# Plan Change Request

Site Address/ Parcel #: 0420331121 Permit #: PRCCP20241189  
Owner: Washington State Fair Email: marty@thefair.com  
Design Engineer: Justin Jones Email: justin@jmjteam.com  
Contractor: Mountain Construction Email: ken@mountainconst.com

➤ Specify the approved civil plans affected: C4-101, C4-103, C4-202, C6-101, C6-102, C6-106

Project:  
**Washington State Fair International Village Redevelopment**

DWG. C6-106  
35 OF 39

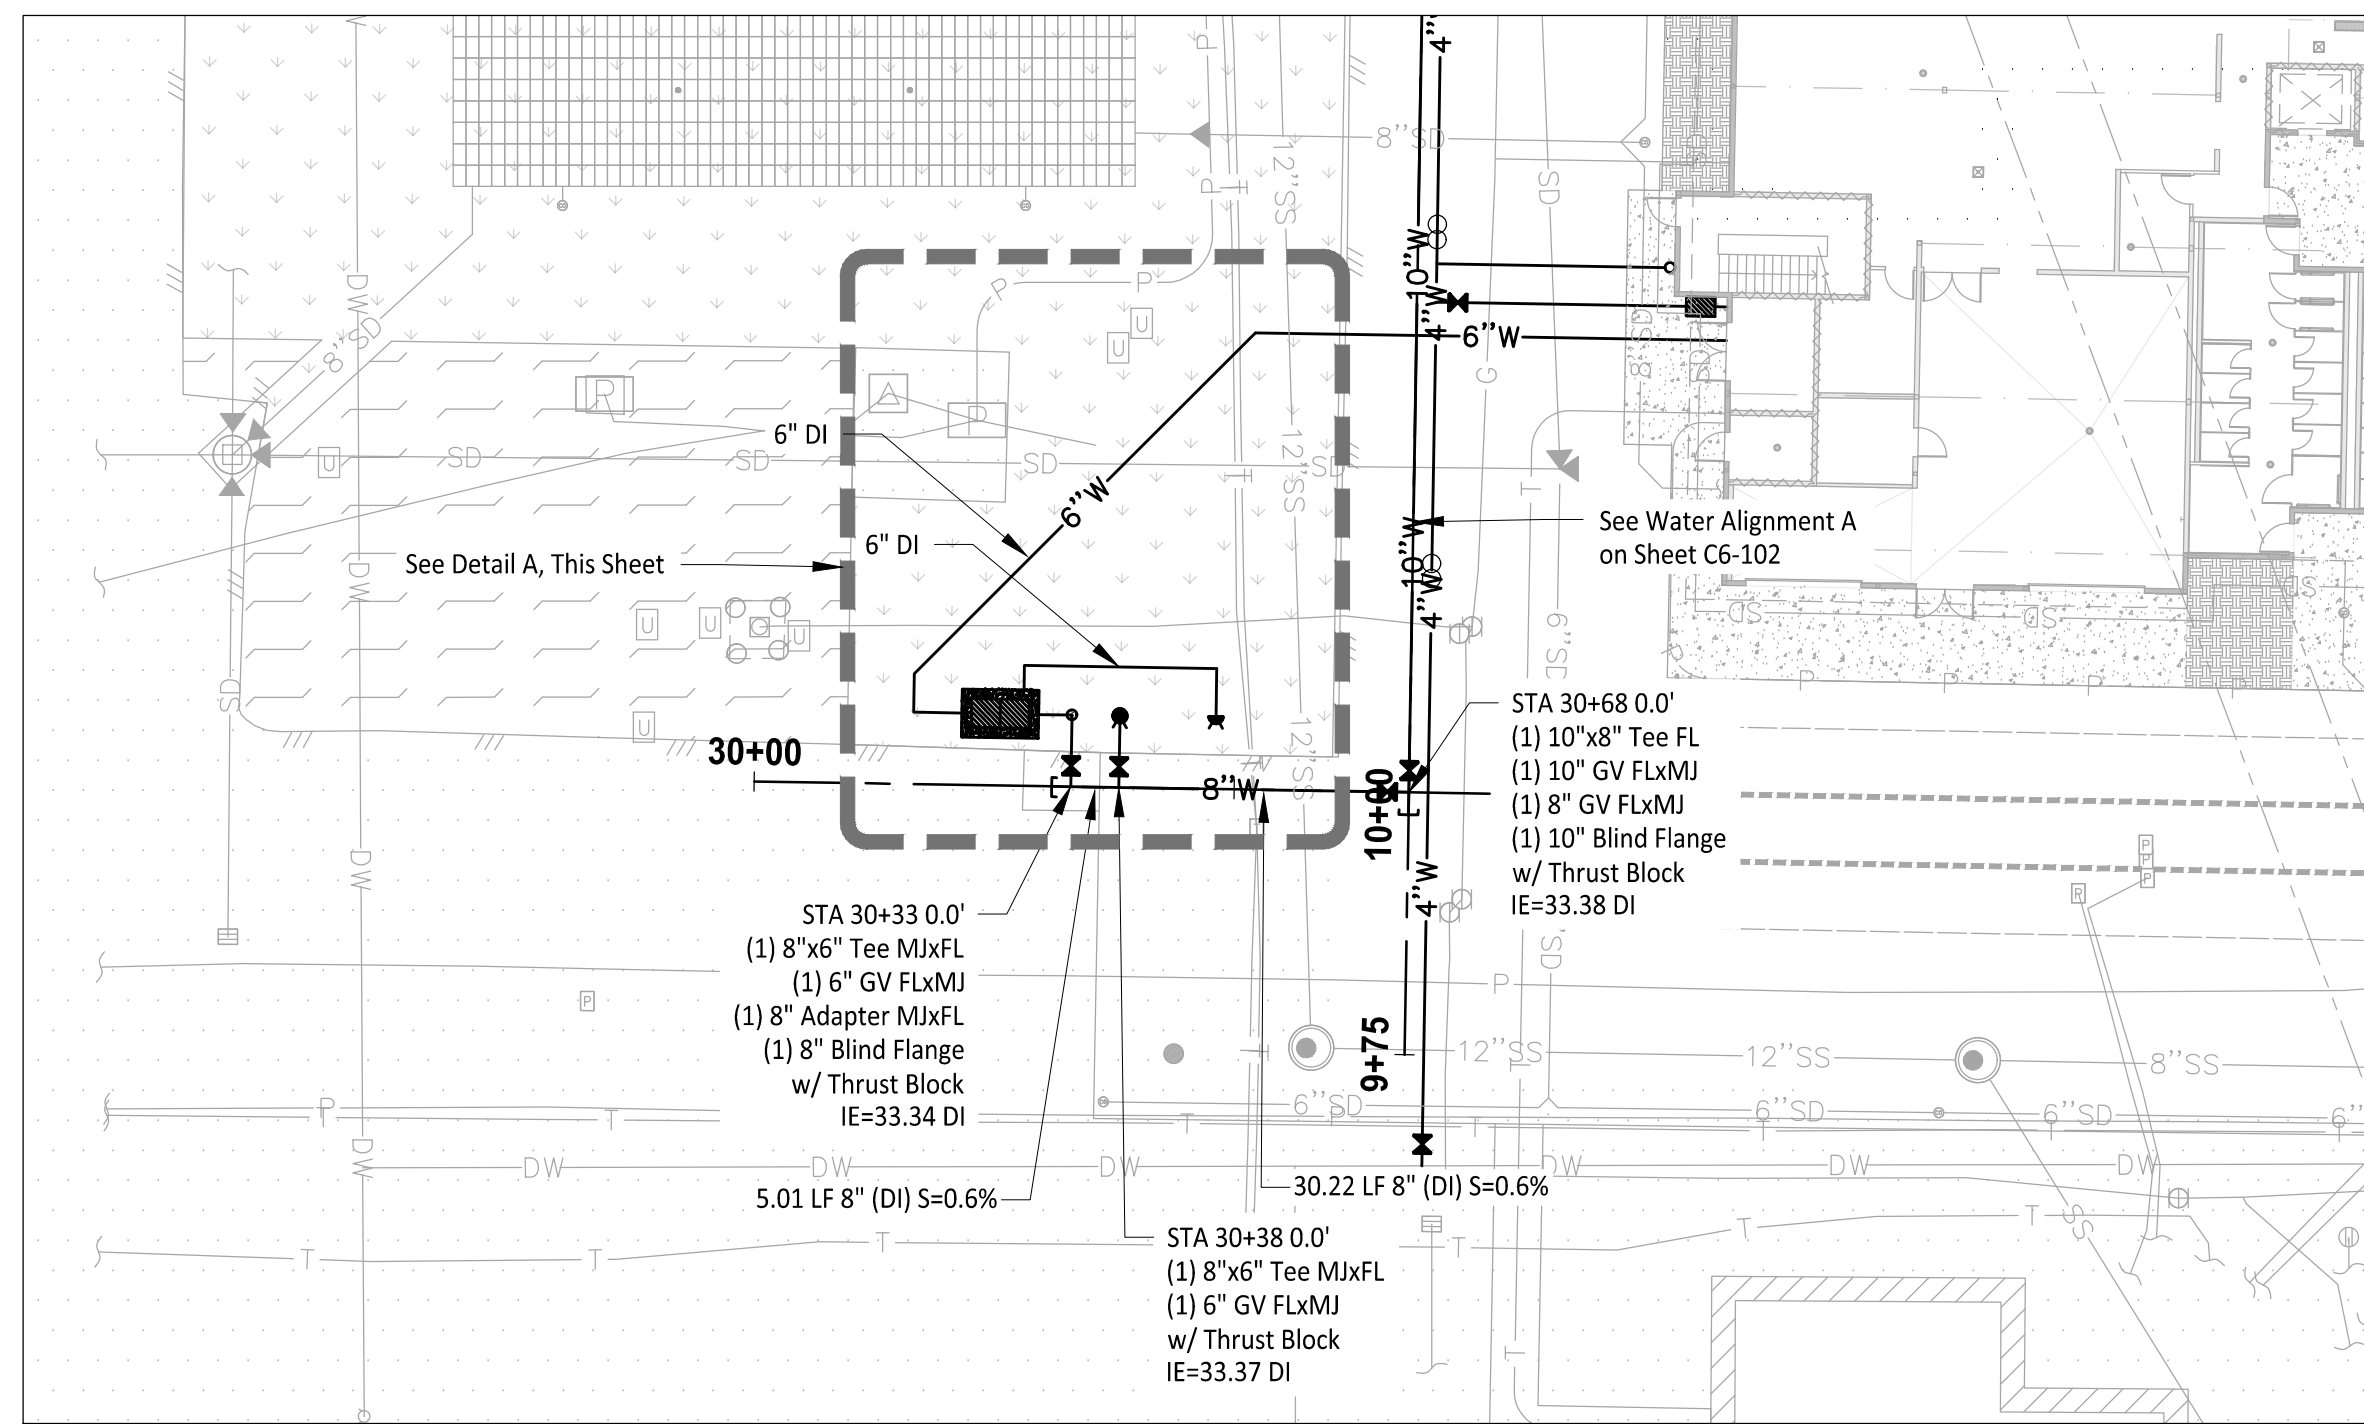
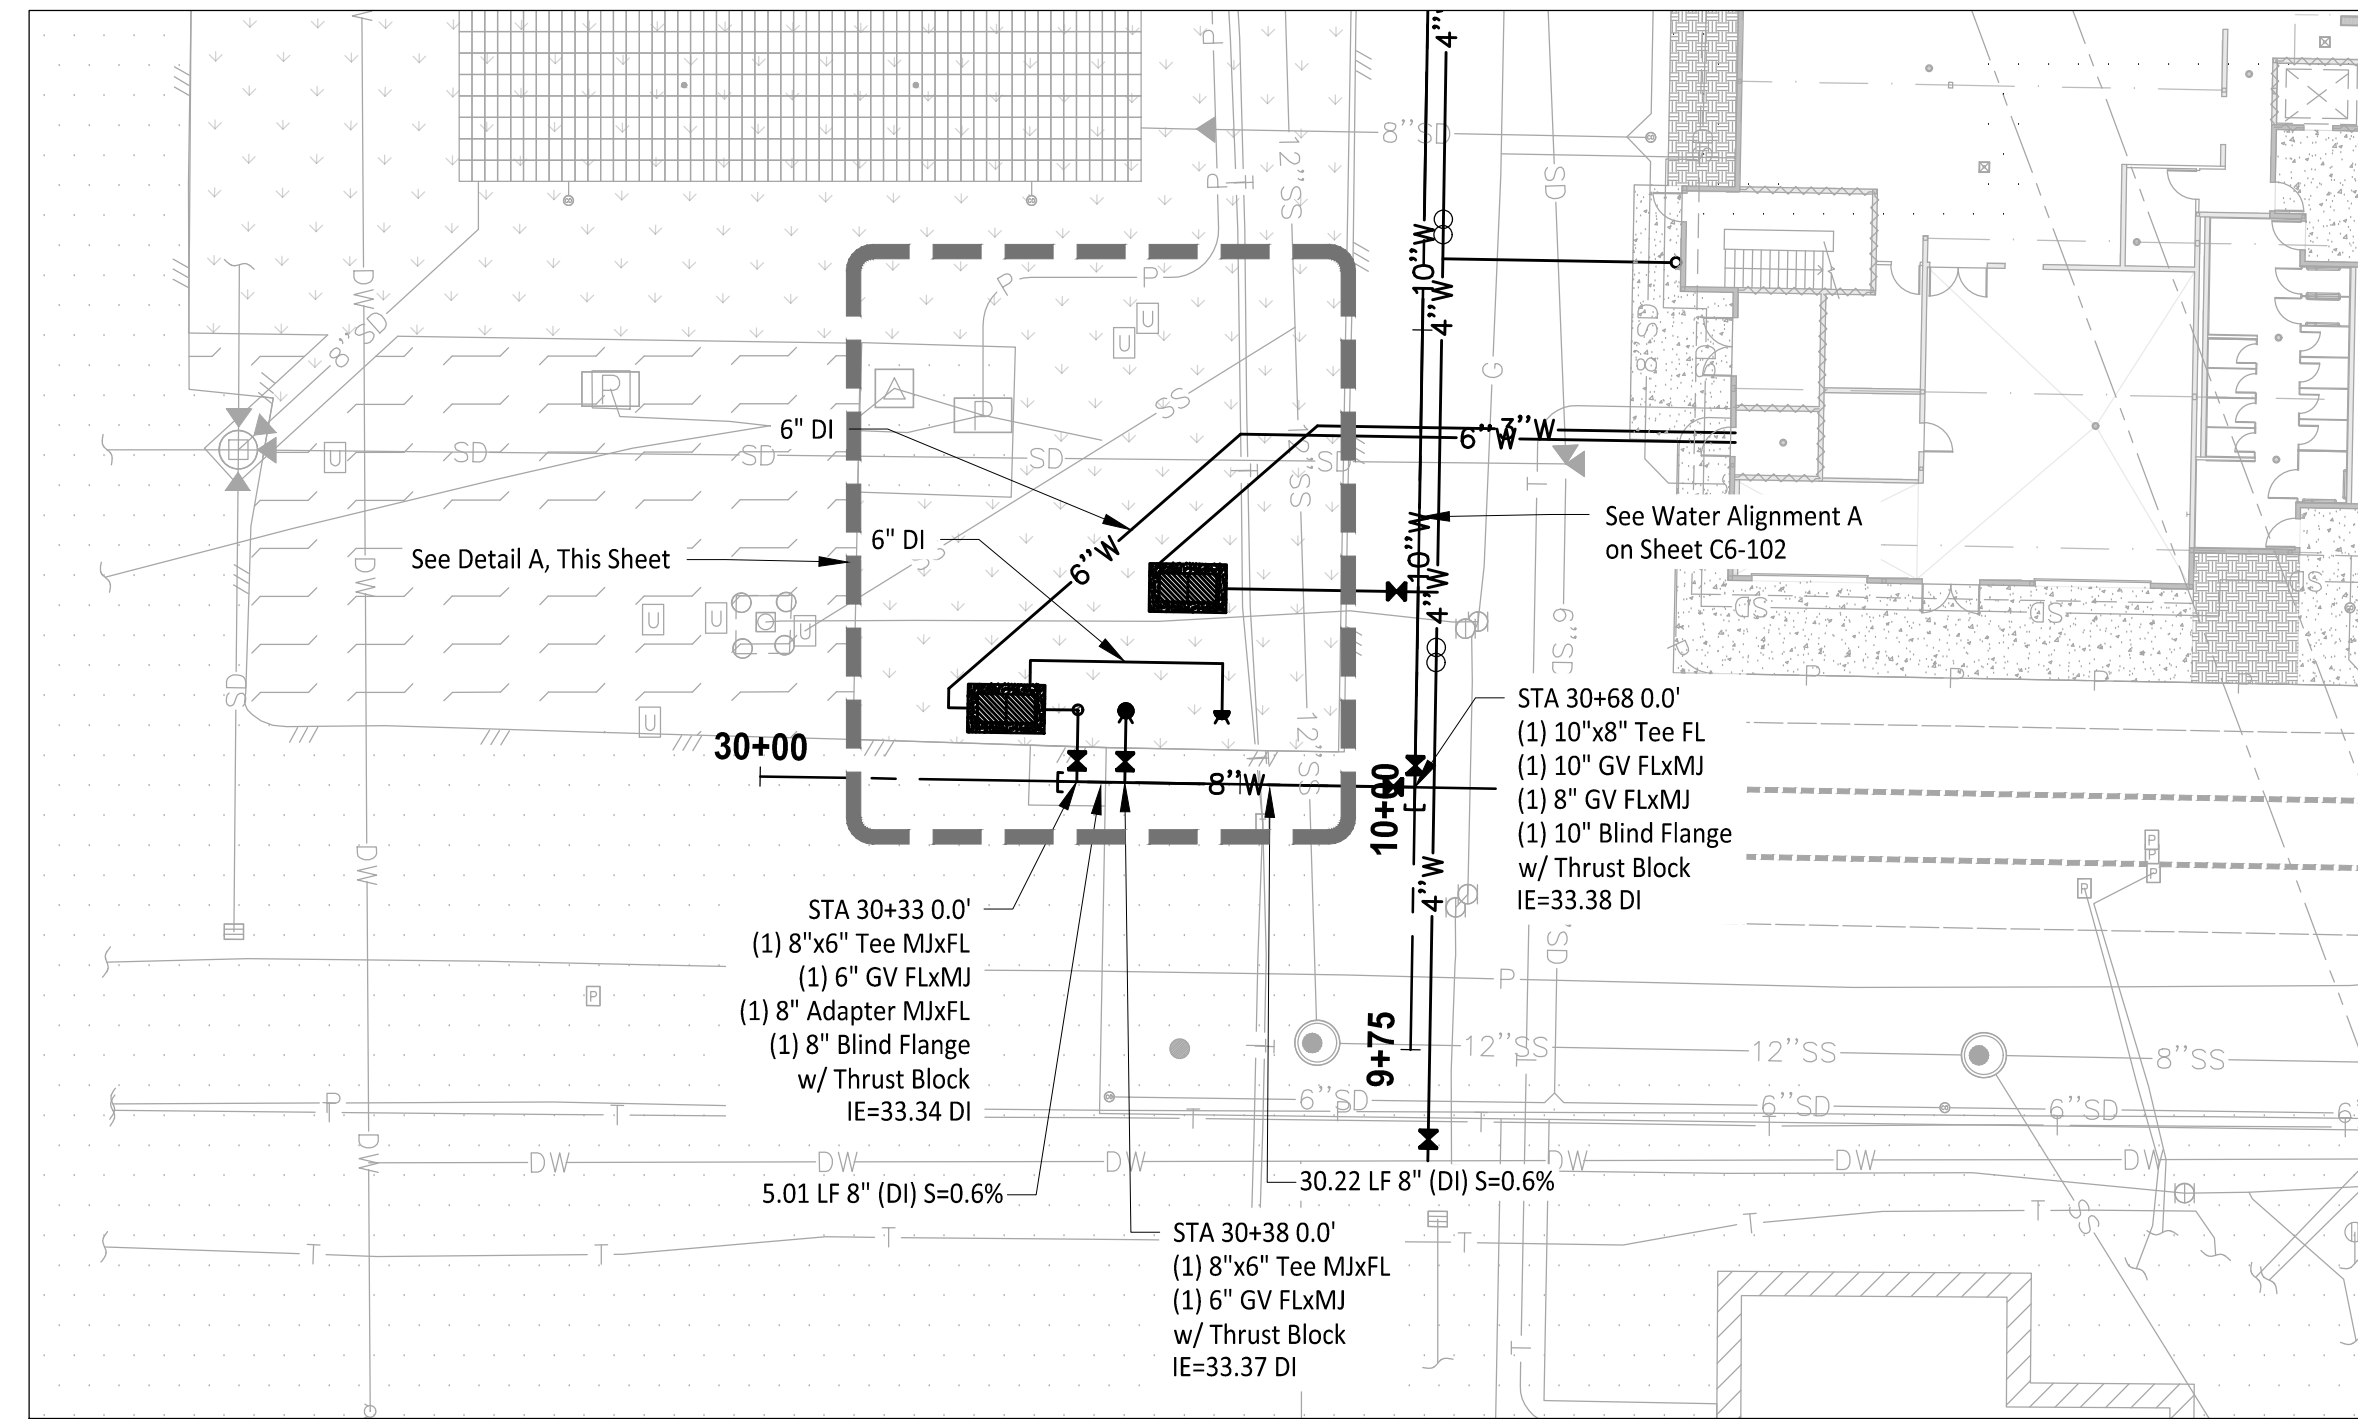
The RPBA has been moved from in front of the west side of the building to the field to the west. Subsequently, the location of the DDCVA will shift within the field.
